UNITED STATES PATENT AND TRADEMARK OFFICE

APPLICATION NO.	FILING DATE	FIRST NAMED INVENTOR	ATTORNEY DOCKET NO.	CONFIRMATION NO.
10/551,827	07/31/2006	Takeyuki Shiomi	3335-00013	3994

Office Action Summary	Application No. 10/551,827	Applicant(s) SHIOMI ET AL.	
	Examiner MELANIE J. HAND	Art Unit 3761

DETAILED ACTION

Fig. 2 of Takao (annotated by examiner)

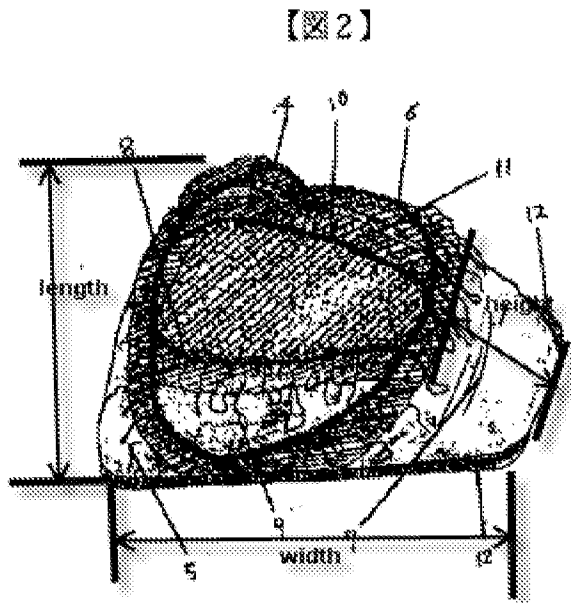
2. Applicant's arguments with respect to claims 52-56 and 58-61 have been considered but are not persuasive. As to the argument that sheets 5,7 disclosed by Takao overlap one another and do not provide an opening to the topsheet, the applicant is referred to Page 5, Fig. 2 of Takao. This figure clearly shows an opening above sheet 9 between the portions wherein sheets 5,7 overlap. Claim 1 only requires that the first and second sheets having ends facing each other in the length direction so as to define an opening therebetween. As to the argument that sheet 9 does not block access in the height direction to the topsheet, it is the examiner's position that access in the height direction entails placing the user's penis in the article in a vertical motion, i.e. in the height direction. This limitation is interpreted in light of the applicant's specification. Since there still must be a space into which the user places his penis, the auxiliary sheet can and must only block access in a portion of the opening. The auxiliary sheet 9 disclosed by Takao is clearly shown in Fig. 2 on page 5 as blocking any access to the top sheet 2 in the back/bottom of the article by the user's penis in the height direction in that particular portion of the opening between the sheets 5,7. Applicant also argues that the examiner is

merely relying upon opinion in the rejection of claim 57, now cancelled, regarding the limitation of an impermeable auxiliary sheet has been added to claim 52. The examiner clearly states in the rejection of claim 57 that the purpose of the auxiliary sheet, just as any outer-facing sheet in that article, is to contain exudate and prevent it from leaking onto the user's skin or undergarment. The gather sheets 5,7 also provide this purpose. A liquid-impermeable sheet prevents exudate from escaping and so the use of such material would be readily apparent to one of ordinary skill in the art. This is not the examiner's opinion. Pursuant to *Graham v John Deere*, a crucial part of establishing a *prima facie* case of obviousness in a rejection under 35 U.S.C. 103 by the examiner is "resolv[ing] the level of ordinary skill in the pertinent art." It is the examiner's position that using liquid-impermeable material for the auxiliary and gather sheets (or any sheet blocking leakage or containing exudate) is well within the level of ordinary skill of one in the pertinent (i.e. absorbent article) art and is a practice so widely known in the art as to not necessitate a secondary reference explicitly mentioning such a widely known practice. As to the argument regarding claim 53 that the auxiliary sheet is located on the other side of the opening relative to the first end of the topsheet in the length direction, the examiner is including below an annotated version of Fig. 2 on page 5 of Takao to clearly establish what the examiner considers the length, width and height directions in the article.

It can clearly be seen from this annotated figure that the auxiliary sheet 9 is located on the other side of the opening relative to a first end of the topsheet in the length direction. The topsheet has four sides defining four ends and one of those ends is necessarily opposed to the sheet in the length direction.

With respect to **claim 53**: The top sheet 2 disclosed by Takao extends between first and second ends in the length direction and wherein the first end of the auxiliary sheet is located between the first end of the top sheet 2 and the first gather sheet 7 in the height direction and wherein the second end of the auxiliary sheet is located on the other side of the opening relative to the first end of the top sheet in the length direction. (Page 5, Fig. 2)

With respect to **claim 54**: The second end of the auxiliary sheet 9 is located between the opening and the second end of the top sheet in the length direction, wherein the second end of the topsheet is the lowermost edge of the article on Fig. 2 on Page 5. (Page 5, Fig. 2)
